Date: 07<sup>th</sup> September 2022  
Our Ref: P1453-1-0010

**Re: Hydrological & Hydrogeological Responses to An Bord Pleanála Further Information Request, and Statutory and Third-Party Submissions, in respect of the proposed Lyrenacarriga Wind Farm, Co. Cork/Co. Waterford (ABP Ref: 309121-21)**

**APPENDIX I: UPDATED Drawing P1453-0-0121-A1-D501-00B**

**Figure A: GSI mapped Mineral Localities in the area of the proposed development site.**  
*(note absence of mineral localities in the area of the proposed development)*

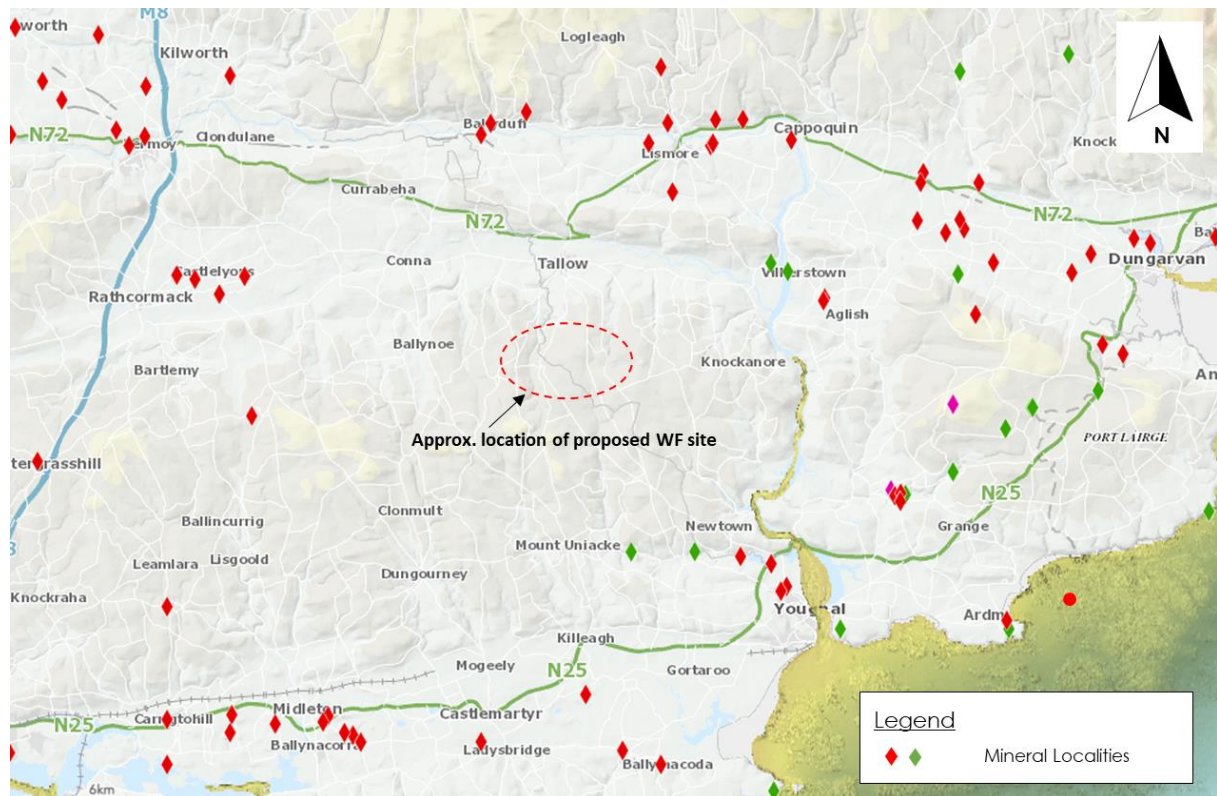
*"You are requested to respond to concerns expressed in respect of the geochemistry of the borrow pit near the entrance, especially in relation to pyrite and/or marcasite and risk of acid drainage".*

- There is no history of mining in the area, suggesting there is no significant mineral resource available in the local bedrock geology. The general absence of mineral localities in the area of the wind farm site confirms this (refer to **Figure A** below);

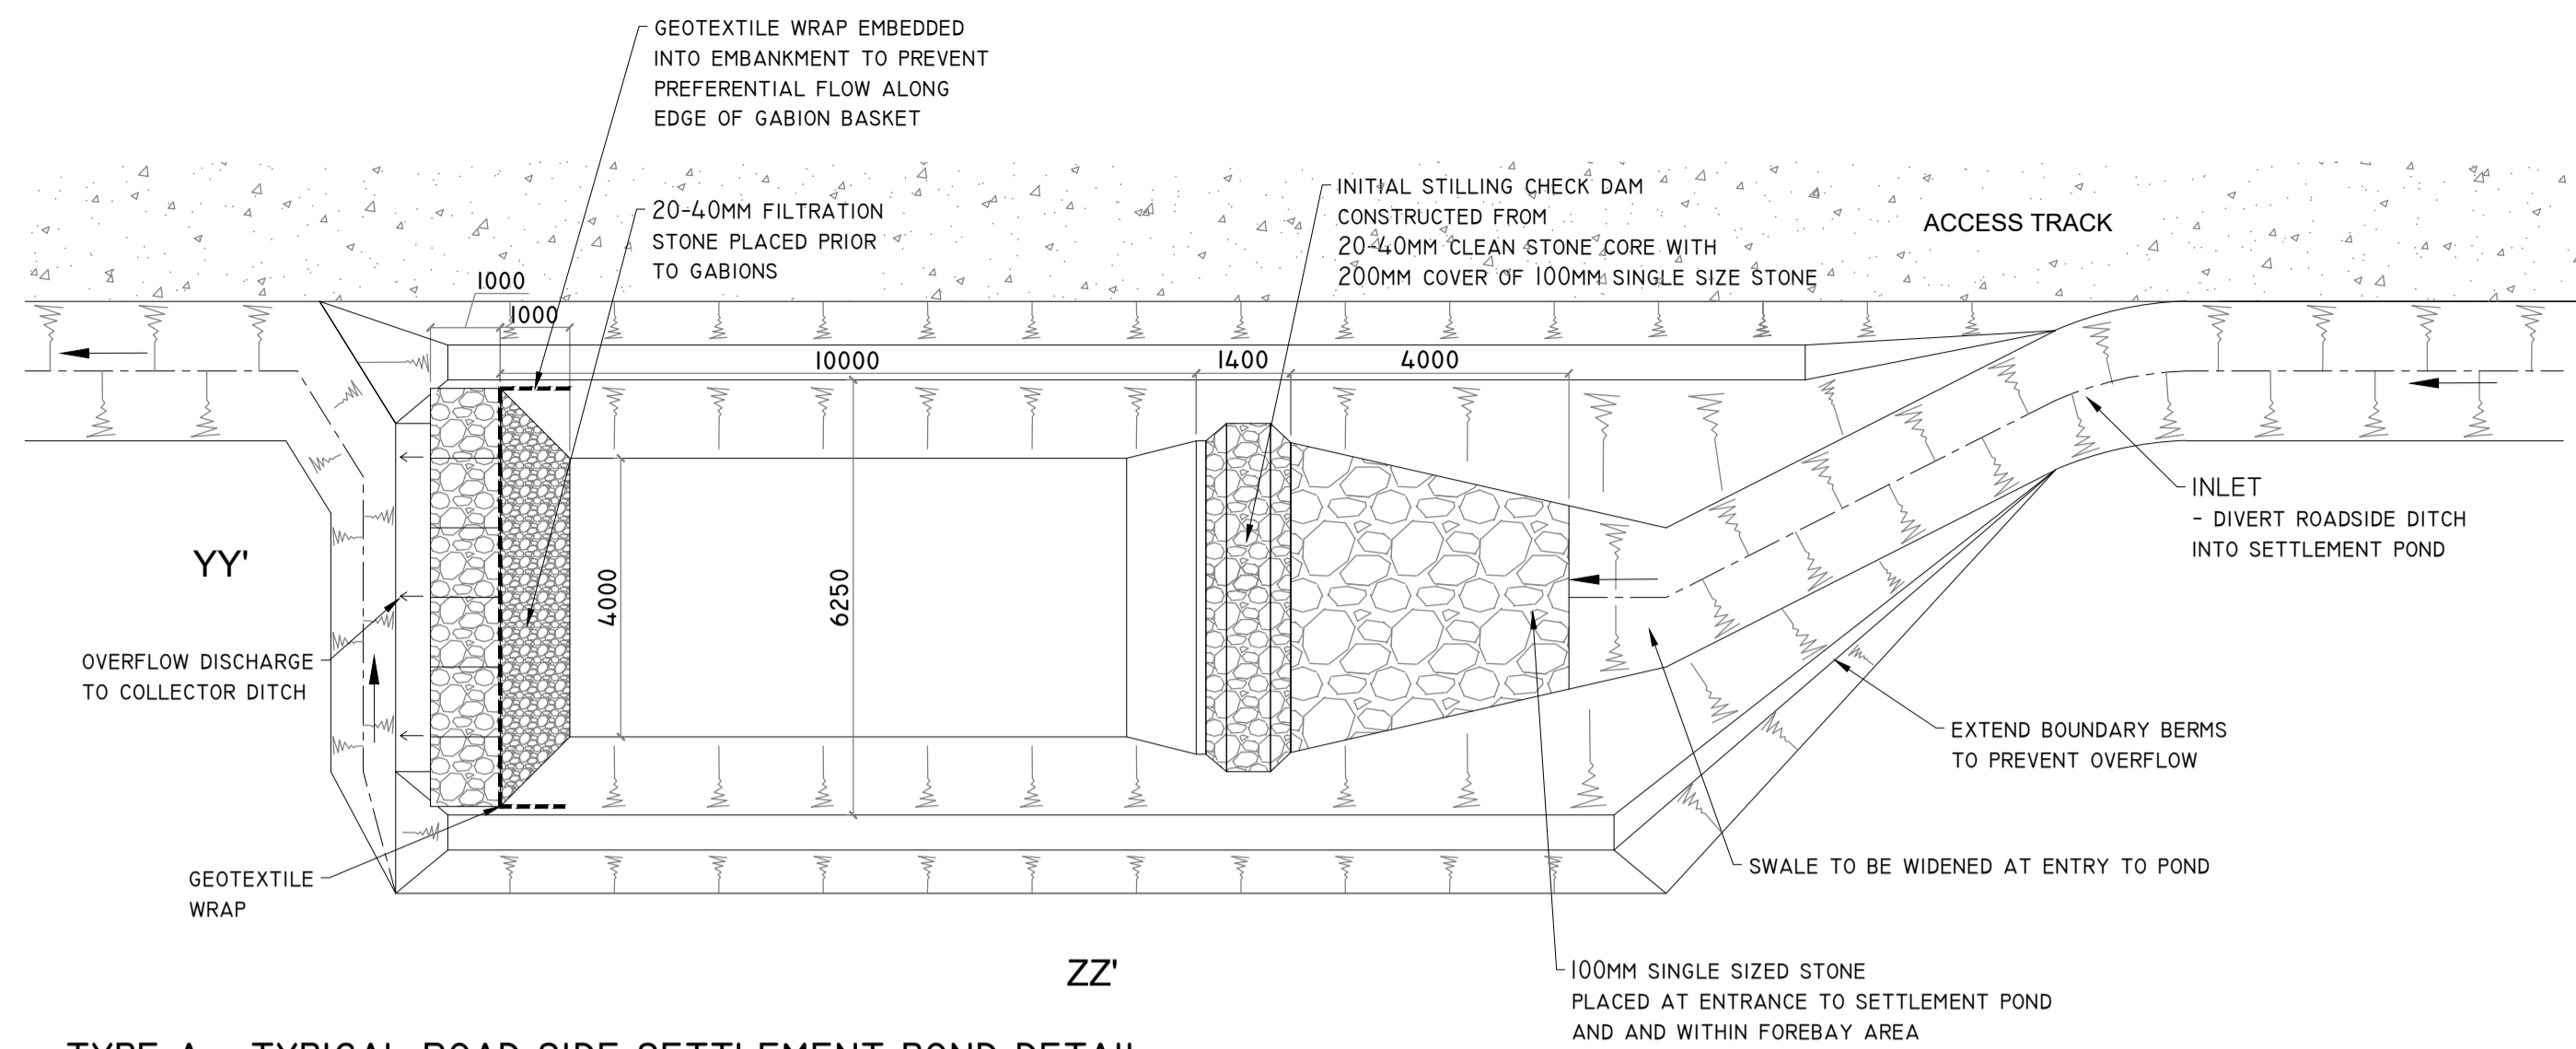
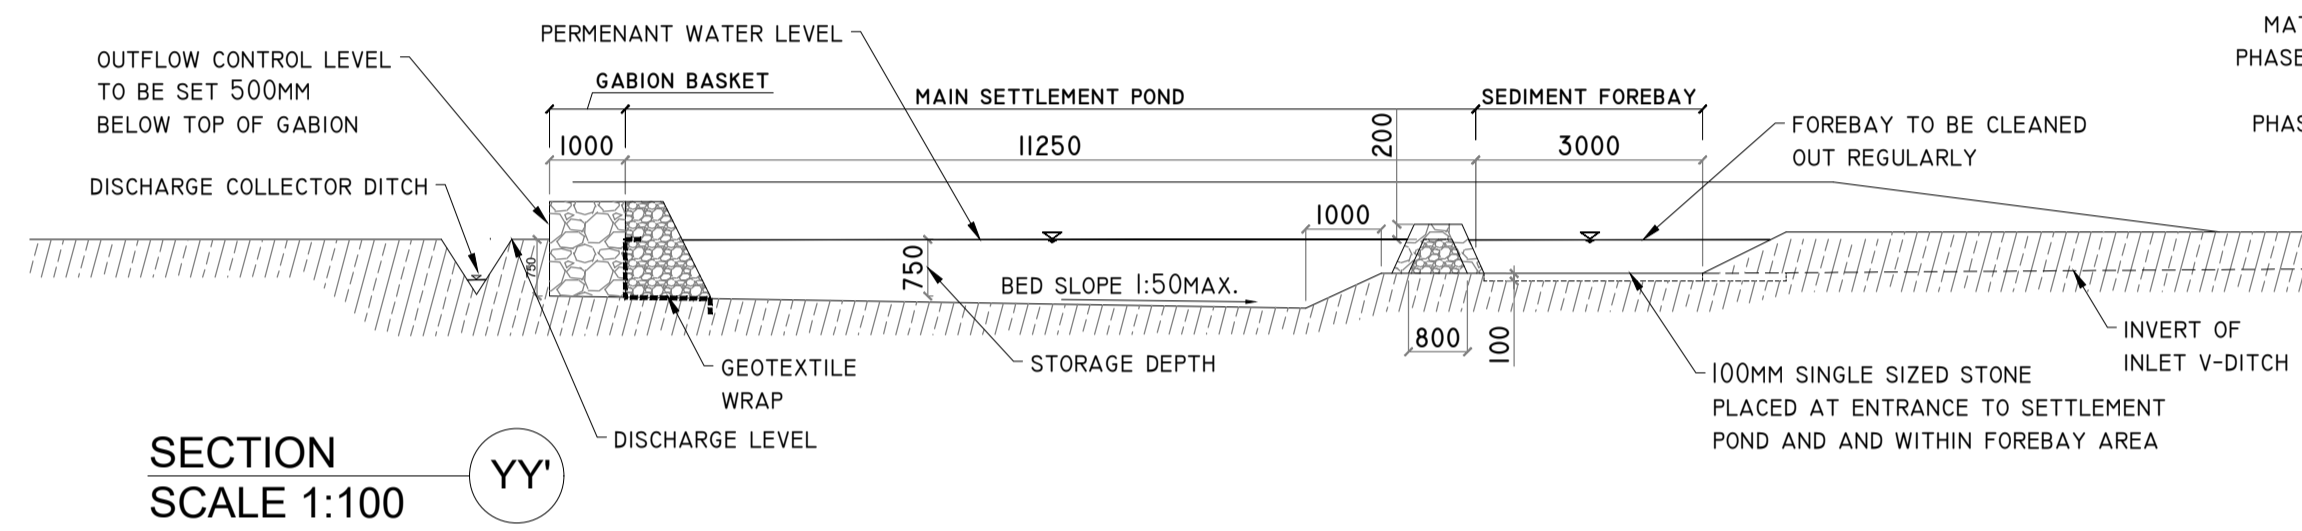
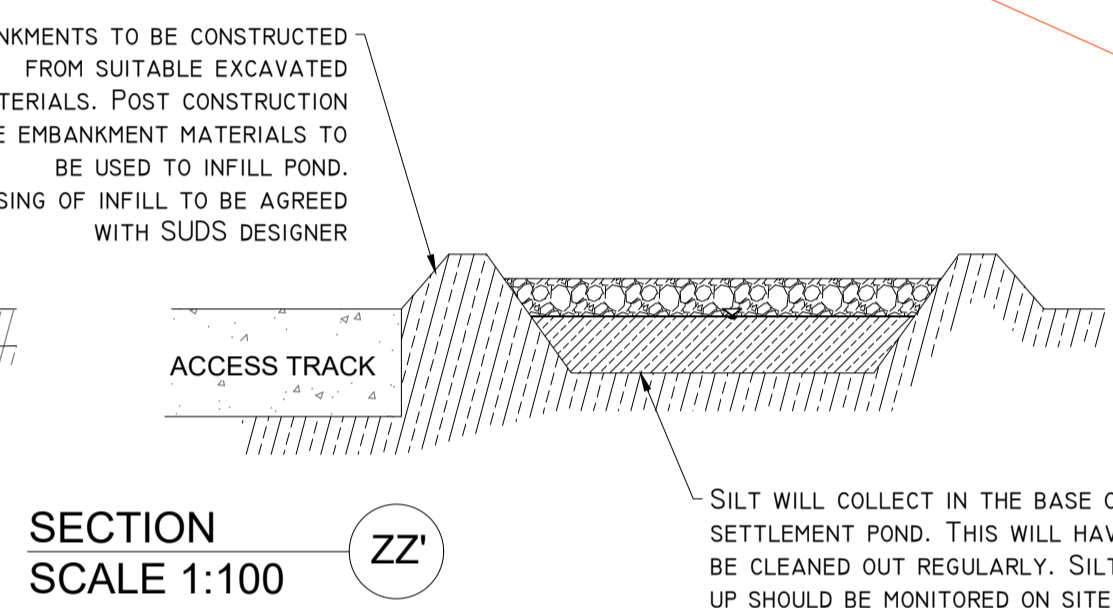
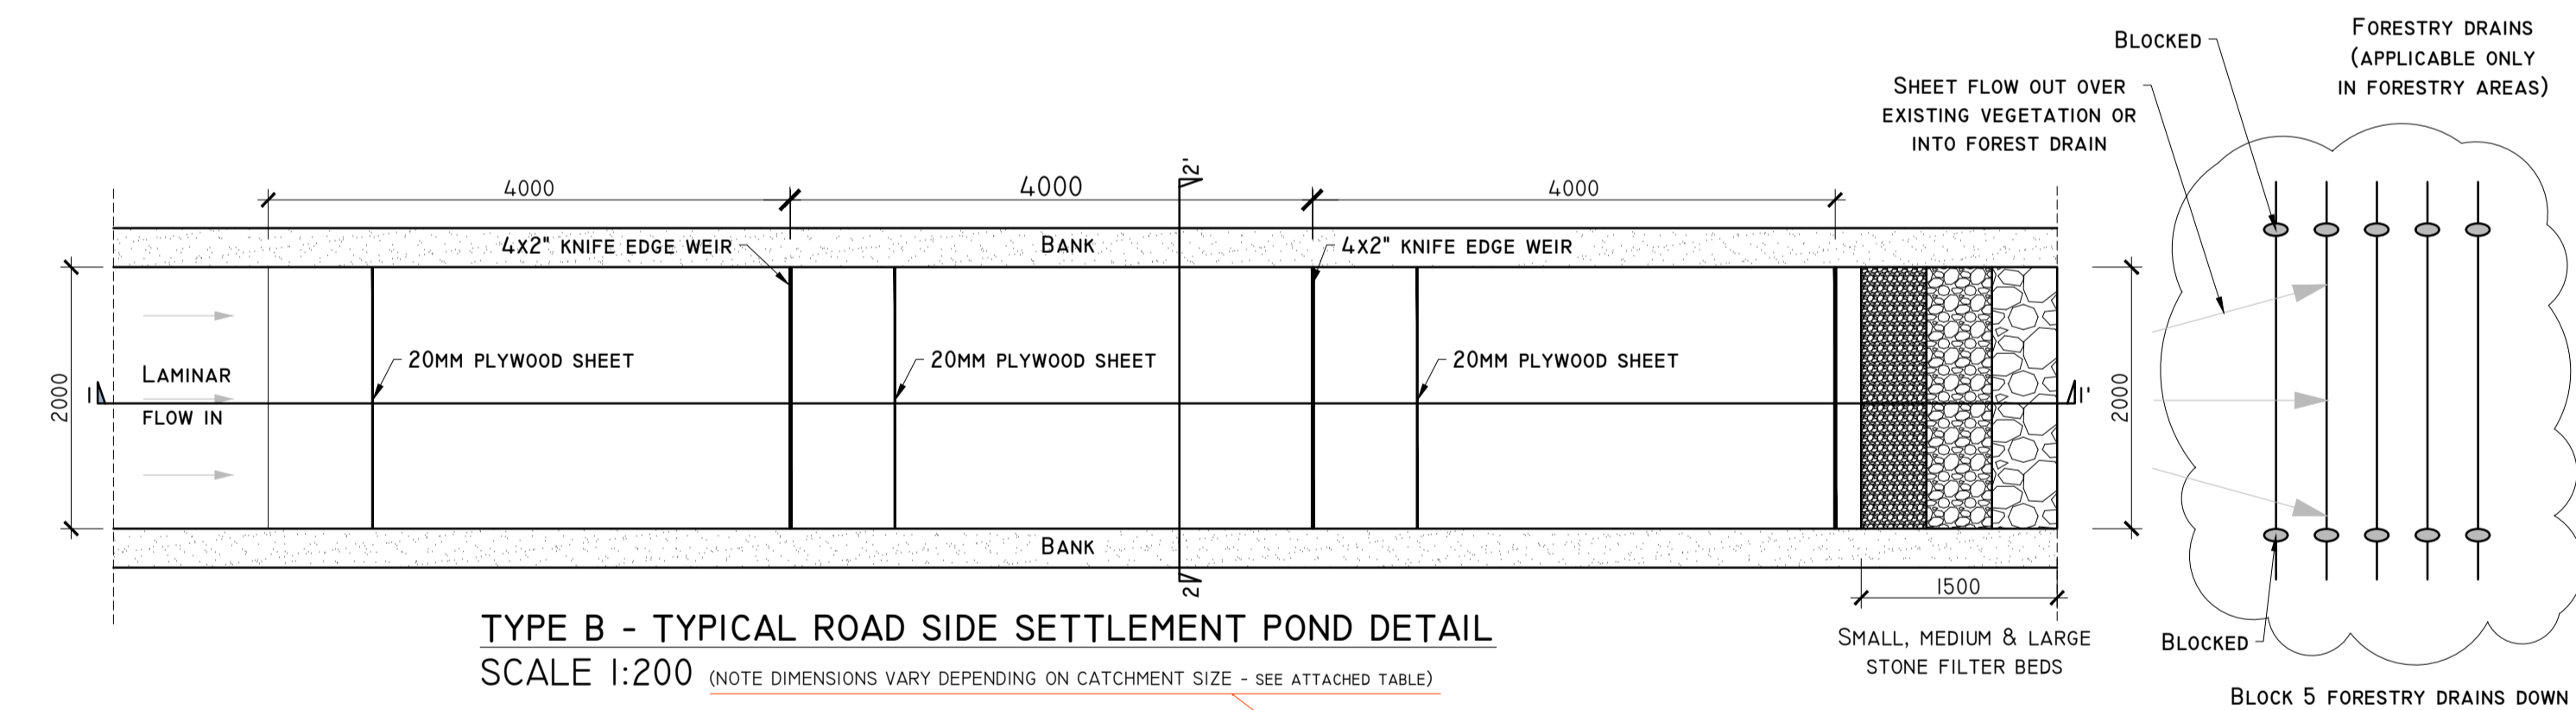
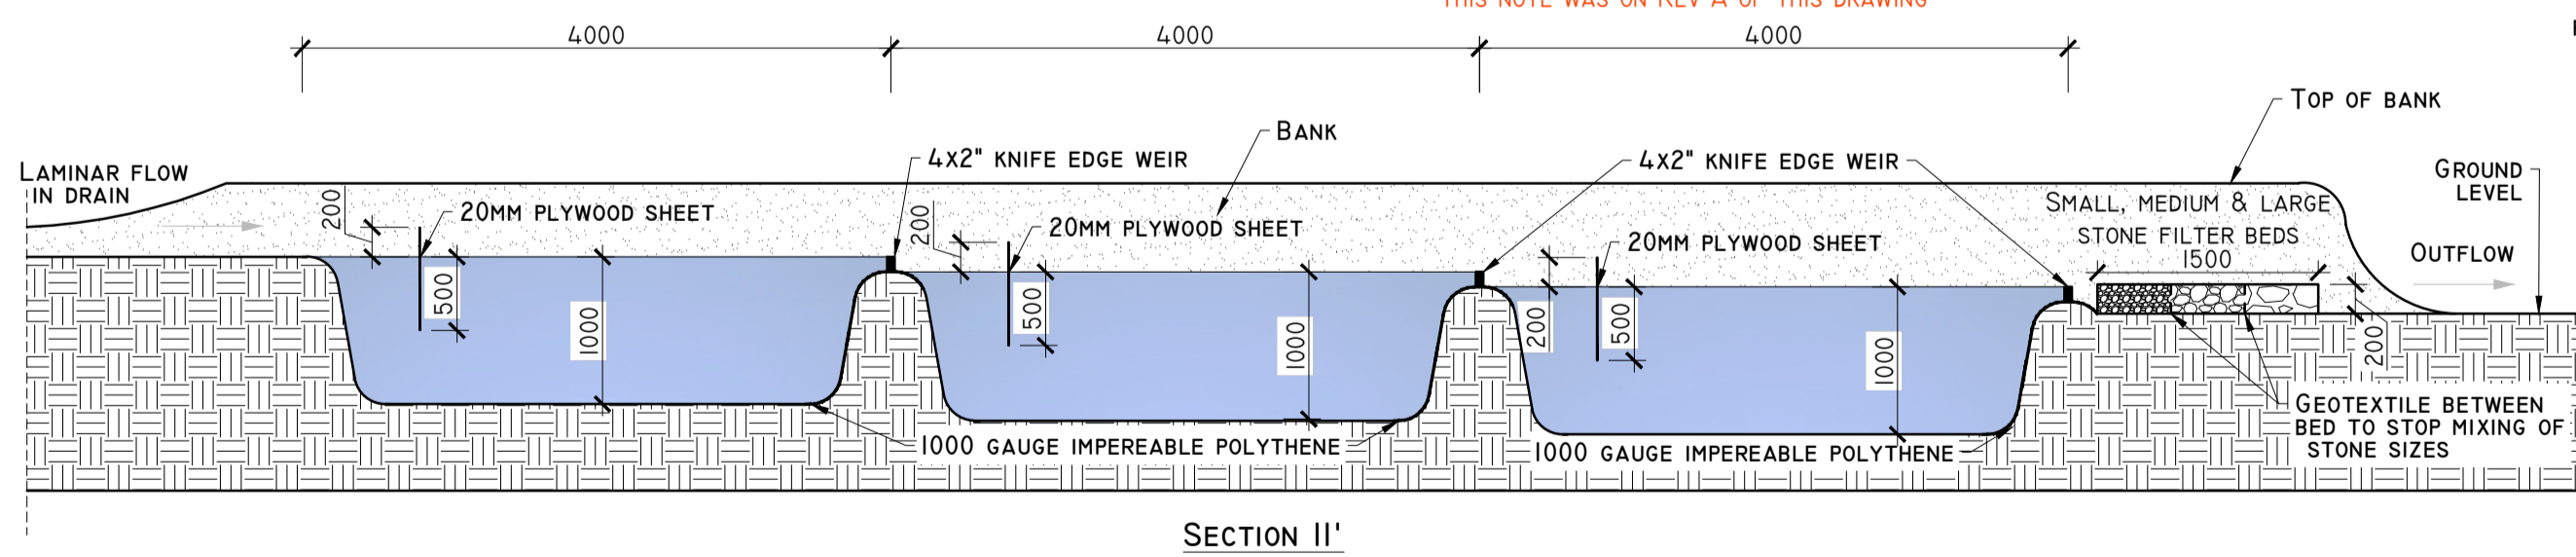
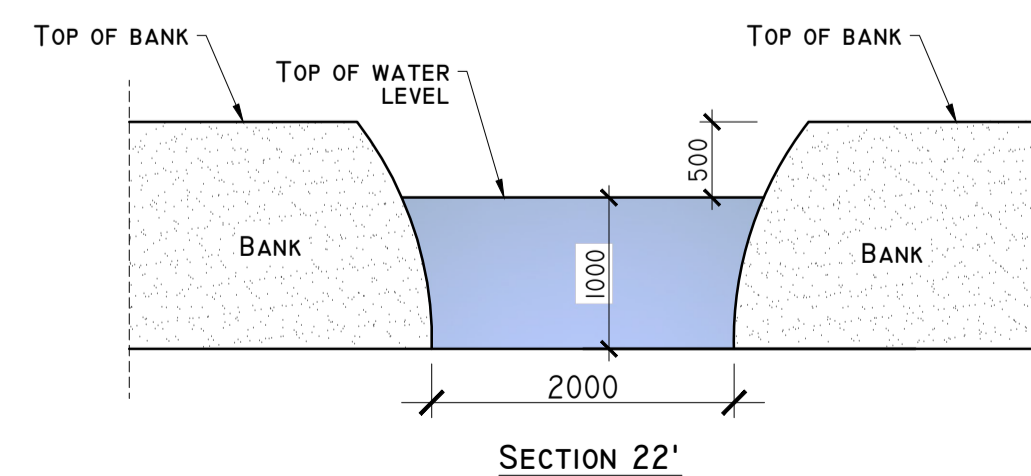
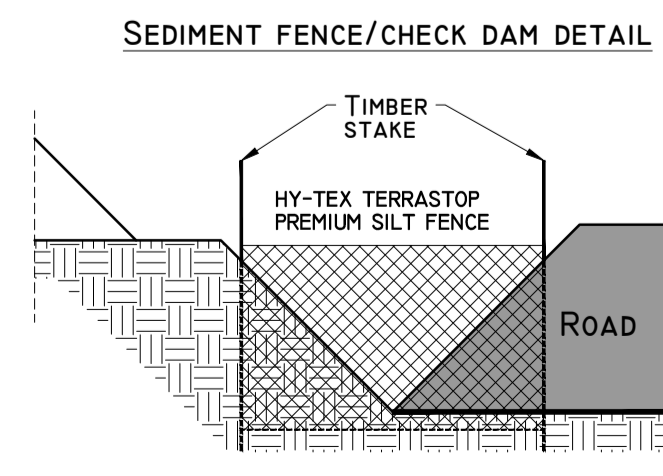
*“Further detail is required in respect of the design detail of the settlement pond structures”.*

There are design specifications referenced in detail A1 and A2 (of drawing P1453-0-0121-A1-D501-00A), but the referenced design table was not included in the final drawing by error (see “Note Dimensions Vary Depending on Catchment Size – See Attached table” referenced below the Title for Type A – Typical Road Side Settlement Pond Detail). An updated version of this drawing is attached in **Appendix I**, and the design table is included on the updated drawing. For clarity, the design table is also presented in **Table A** below. Please note that **Table A** covers a series of catchment sizes and design scenarios that will typically be encountered at the site.

As shown in detail A1 and A2 of that drawing (P1453-0-0121-A1-D501-00A), temporary settlement ponds will be constructed from suitable excavated soil material and lined with 1000 gauge impermeable polythene. The settlement ponds will be a 2-stage, or a 3-stage, construction (i.e. there will be either 2 stages of settlement, or 3 stages, broken into bays within the settlement pond structure).

Return Period	100-year	Catchment Size (m <sup>2</sup> )		
		500	1,000	2,000
6hr retention for Coarse Silt		2.8 x 9 x 1	4 x 13 x 1	5.7 x 18 x 1
11hr retention for Medium Silt		3.2 x 10 x 1	4.5 x 14 x 1	6.4 x 20 x 1m
24hr retention for Medium Silt		3.5 x 11 x 1	5 x 16 x 1	7 x 22 x 1
Settlement Pond Size:		W[m] x L[m] x D[m]	W[m] x L[m] x D[m]	W[m] x L[m] x D[m]

THIS NOTE WAS ON REV A OF THIS DRAWING

THIS TABLE WAS OMITTED IN ERROR FROM REV A OF THIS DRAWING
